Service Manual

CD Stereo System

Model No. **SA-AKX32PH**
SA-AKX32PN
SA-AKX32PR
SA-AKX52EB
SA-AKX52EG
SA-AKX52GN
SA-AKX52PH
SA-AKX52PN
SA-AKX72PH
SA-AKX72PN
SA-AKX92PH

Subject : Updates on Printed Circuit Board, Schematic Diagram, Exploded View,
Parts List & Troubleshooting Guide.

2.2. SMPS Circuit (SA-AKX32PH/PN/PR-K)

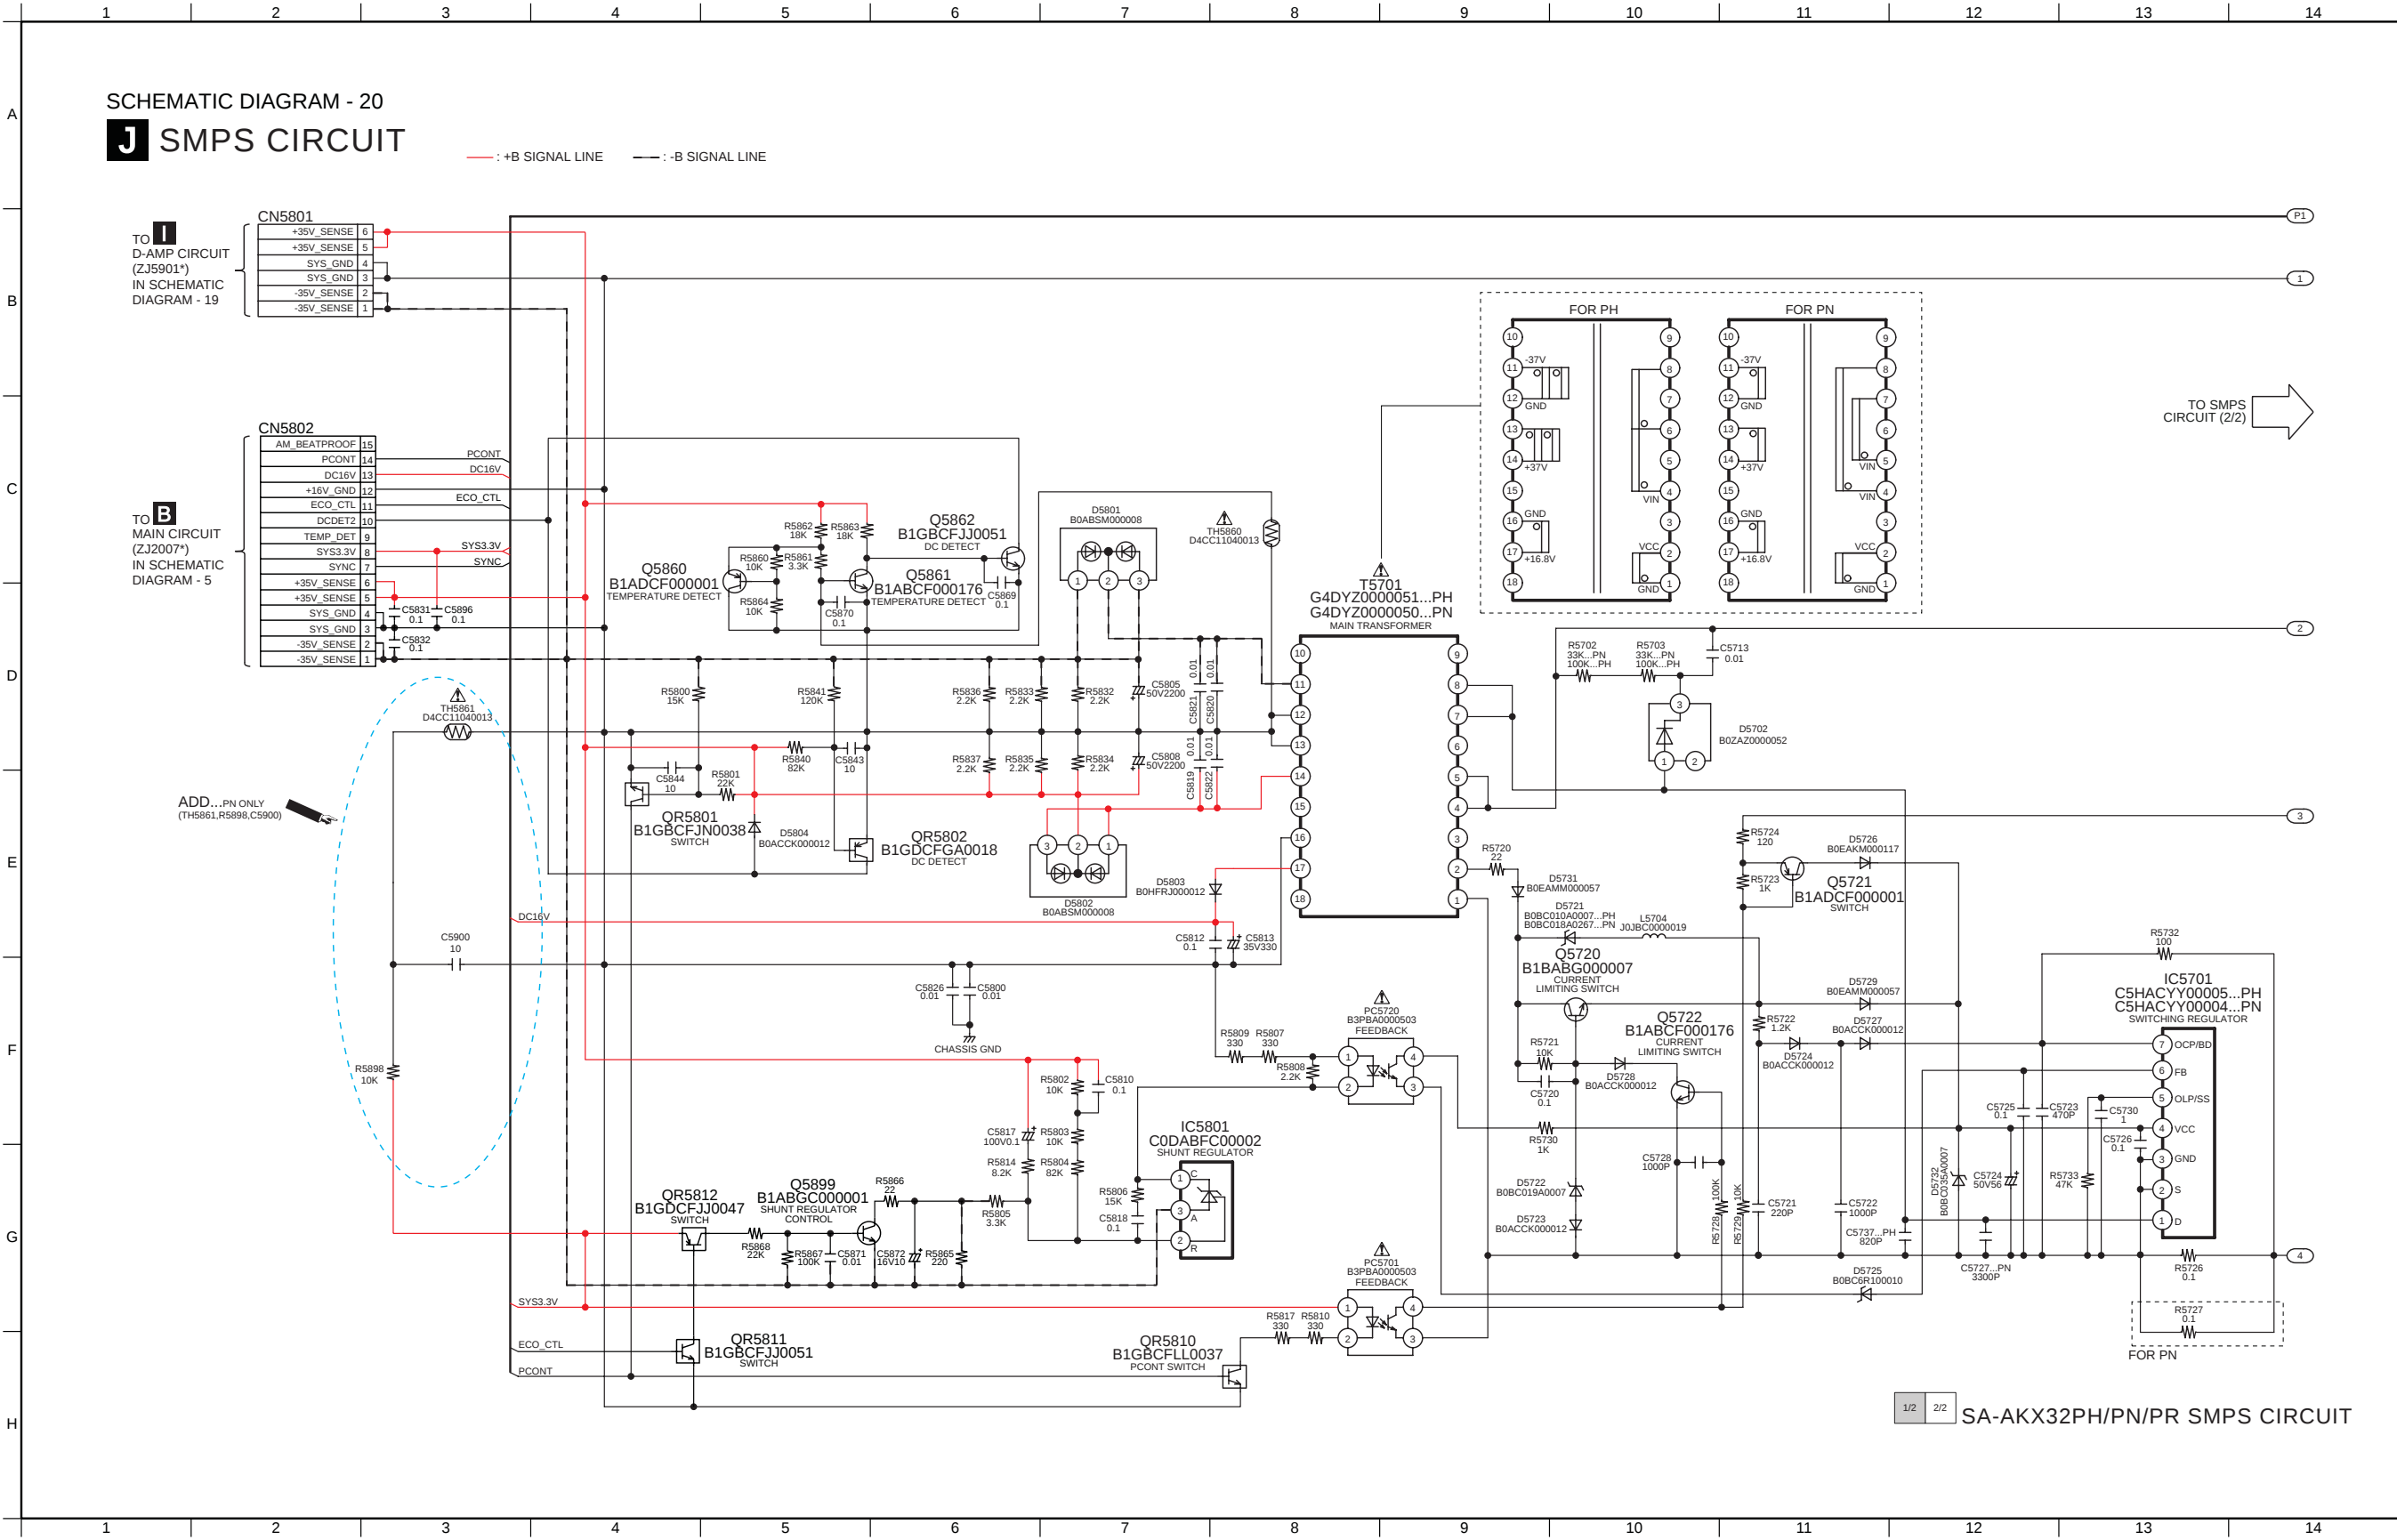
With reference to original service manual (section 17.9) on page 110.

2.3. Main Circuit (SA-AKX52EB/EG/GN-K)

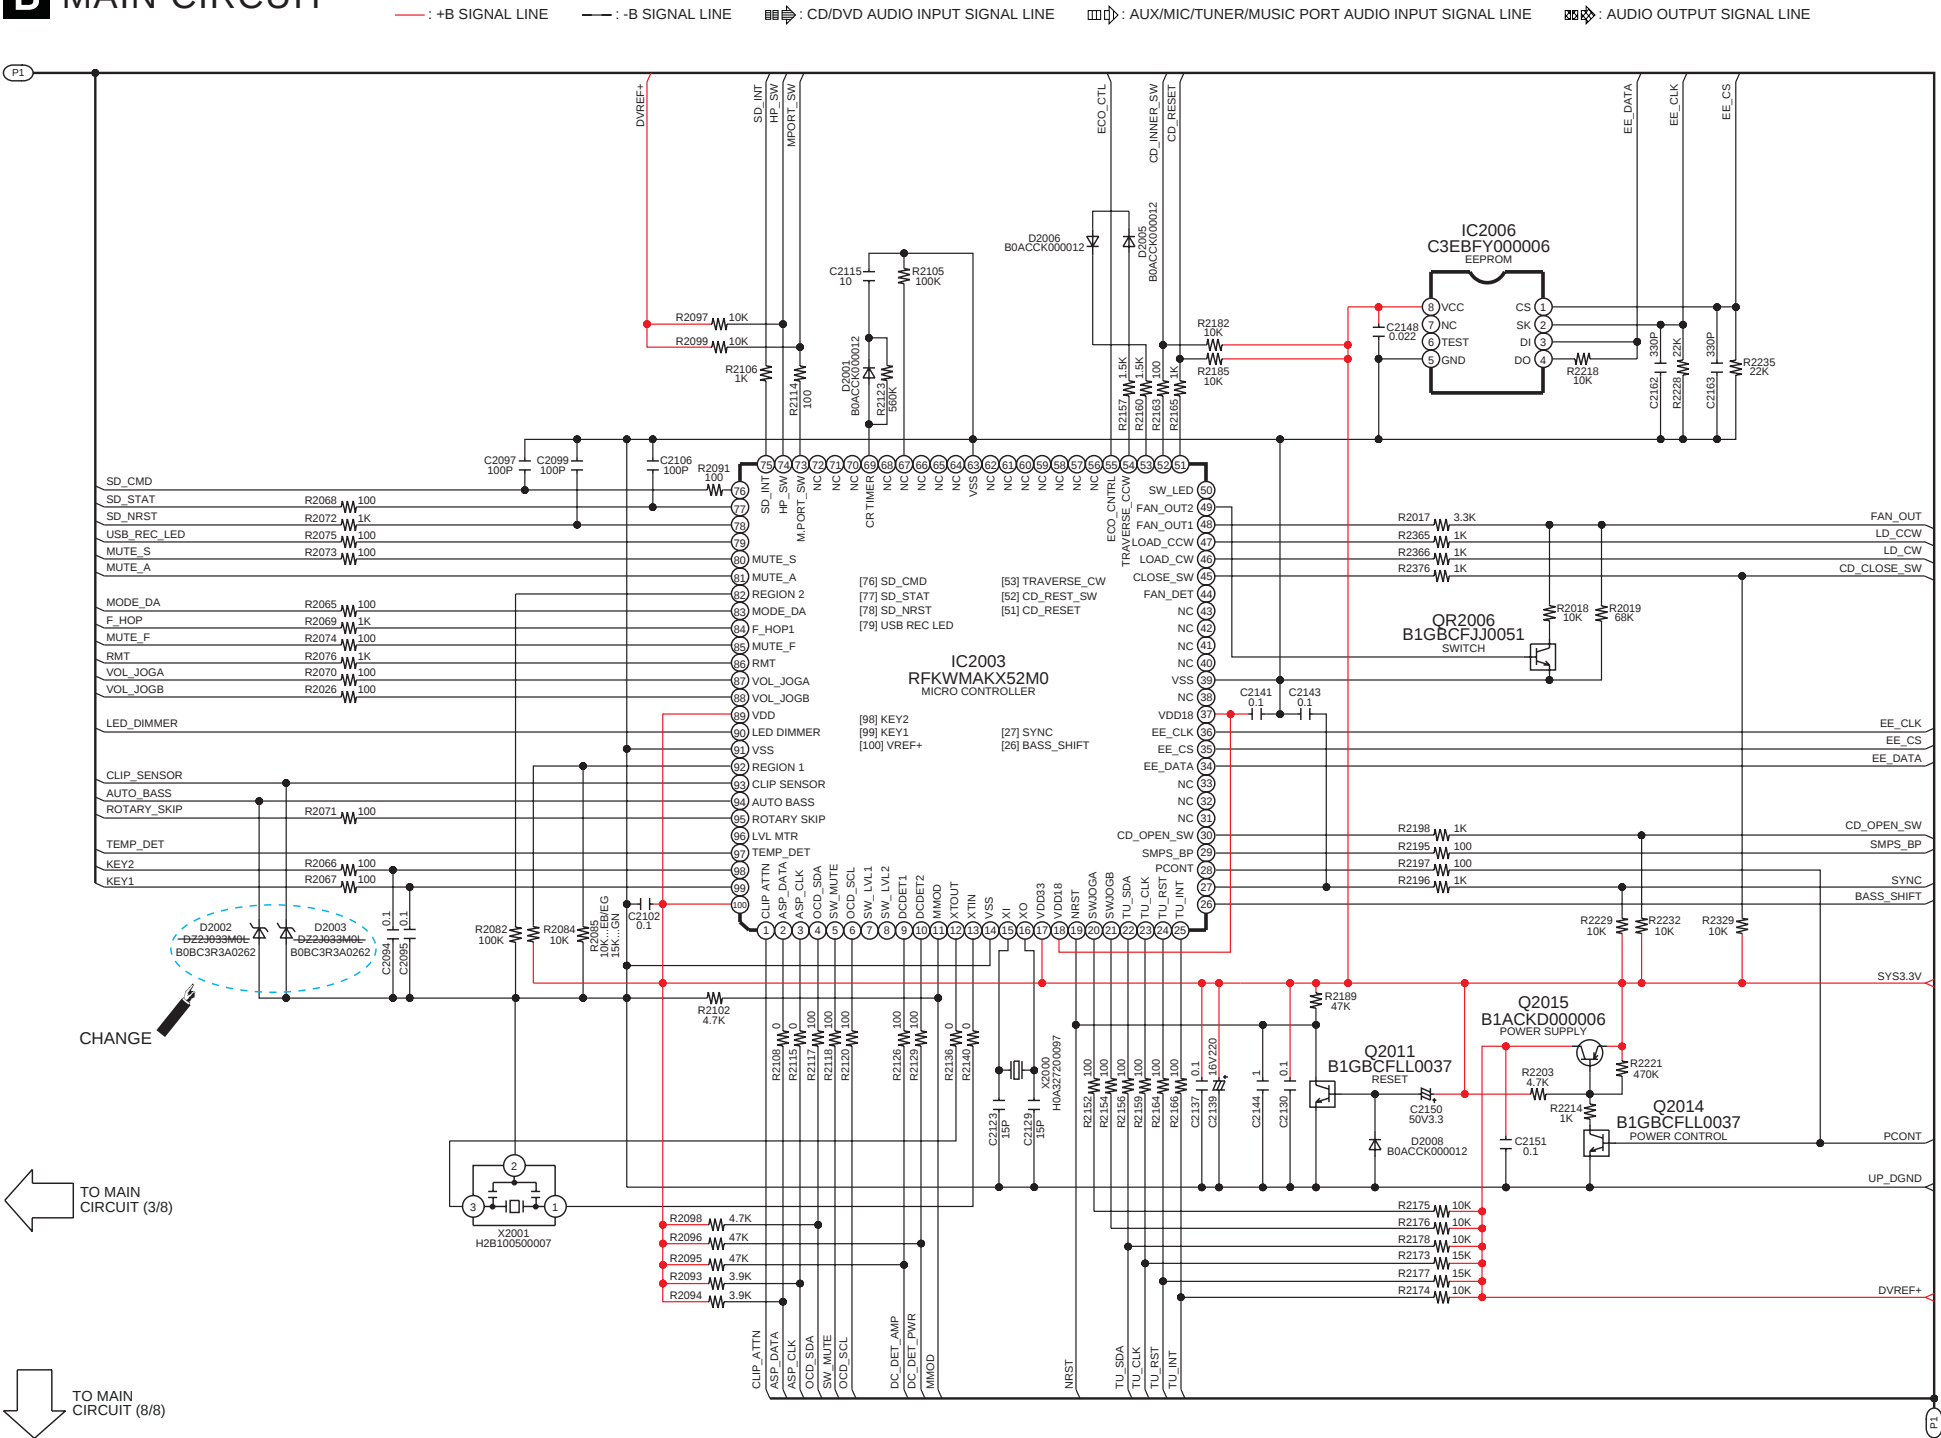
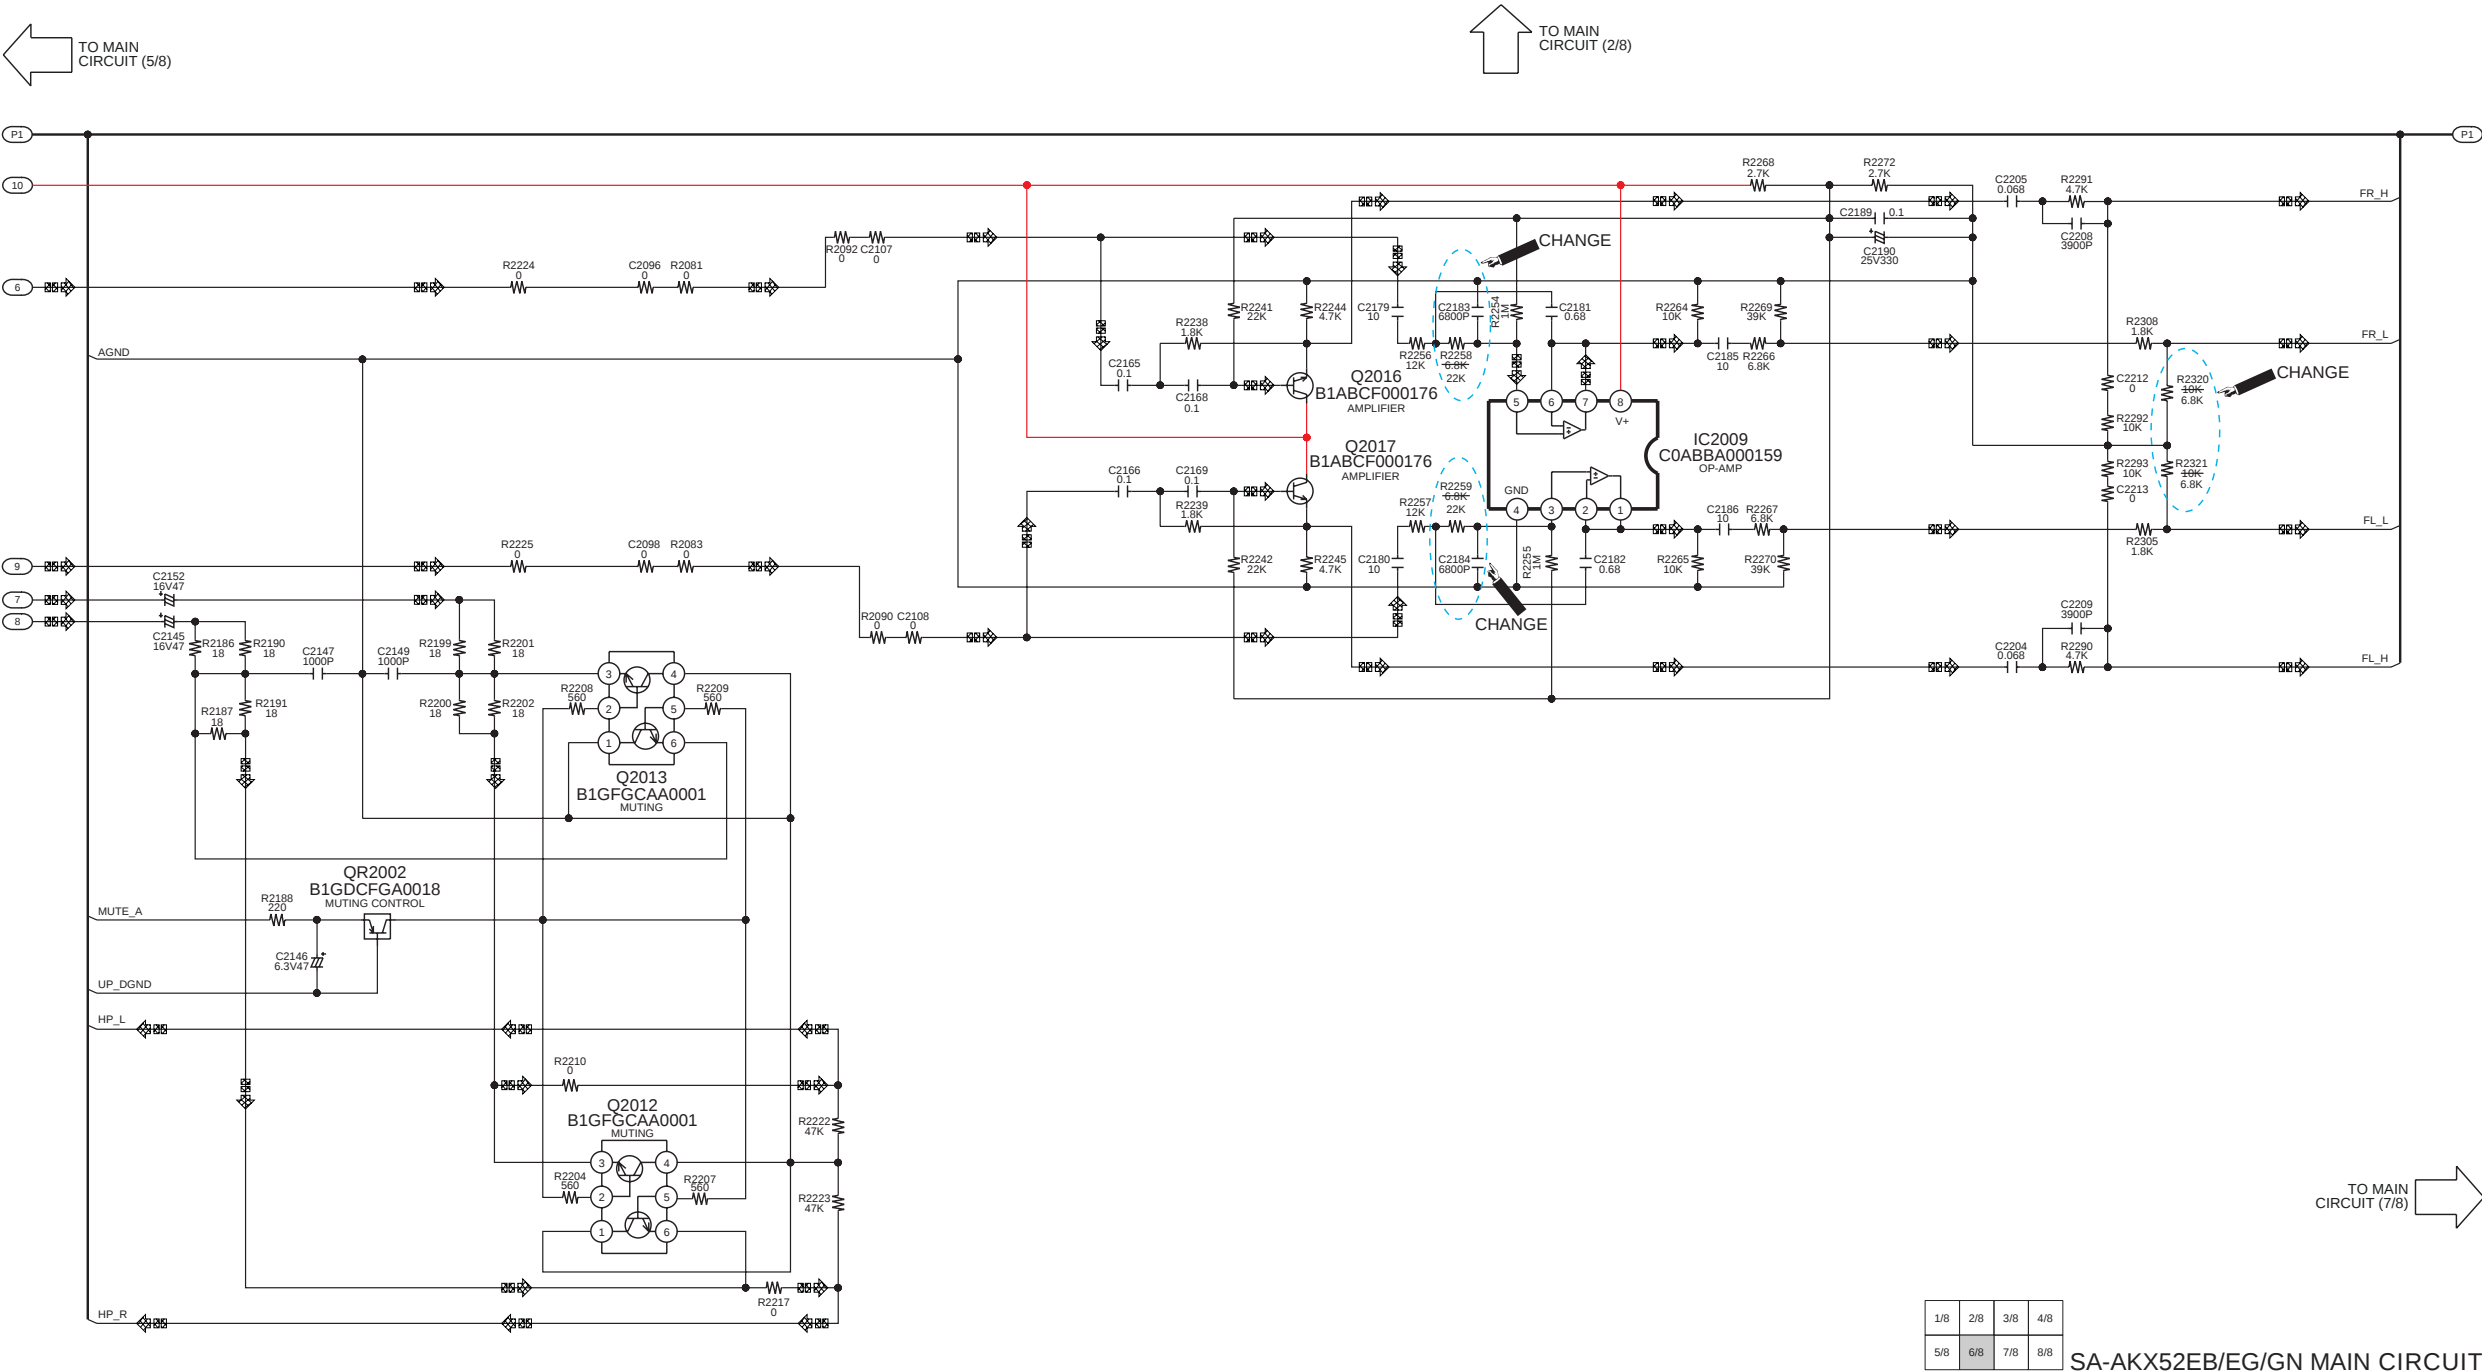
With reference to original service manual (section 17.3) on page 96, 97 & 98.
